SEAOE Seismic Design Manual (1997 UBC Version)
 Errata No. 1 for Volume II

Figure 1-19. Detail of anchorage at point A (see also Figure 1-18)

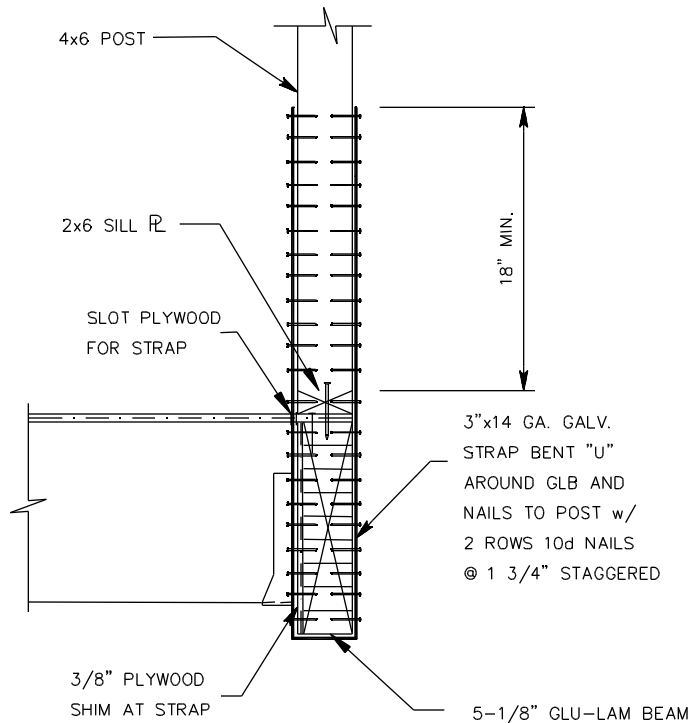
Page 77, Design Example 1:

Figure 1-19, add sill plate and GLB cross-section symbols:

Figure 3-10. Typical tiedown connection at the second floor on line C

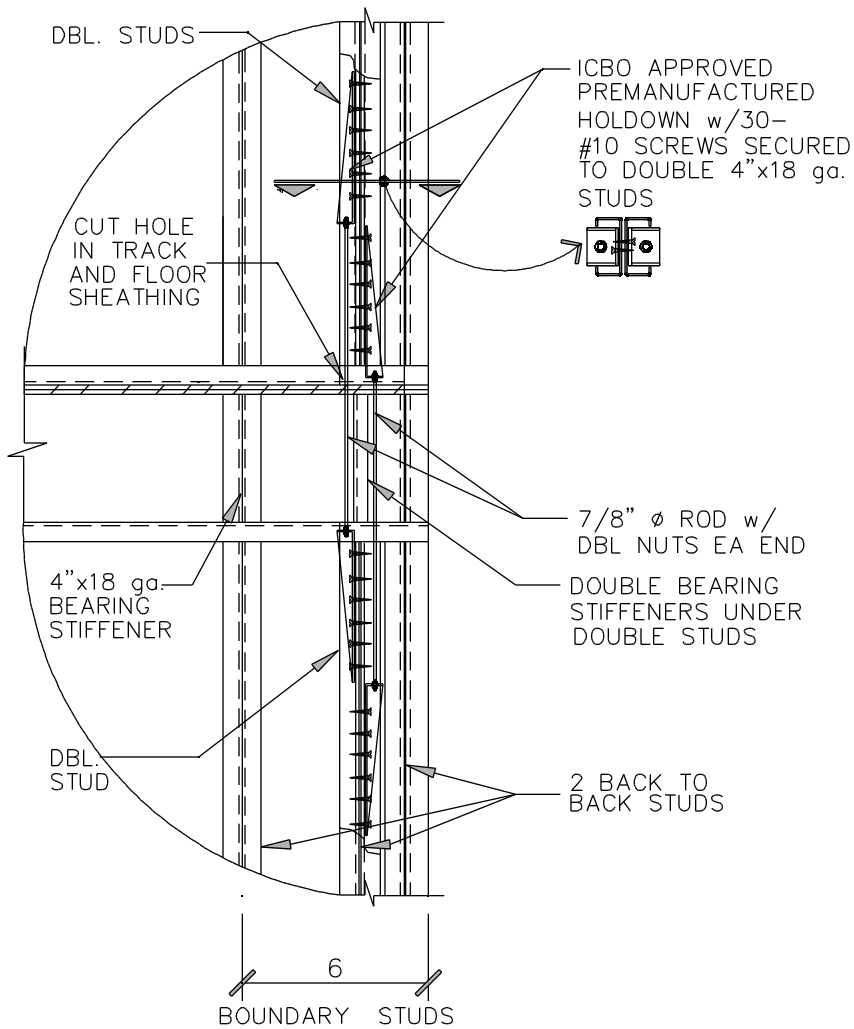
Page 202, Design Example 3.

Figure 3-10, change the number of boundary studs from 5 to 6:
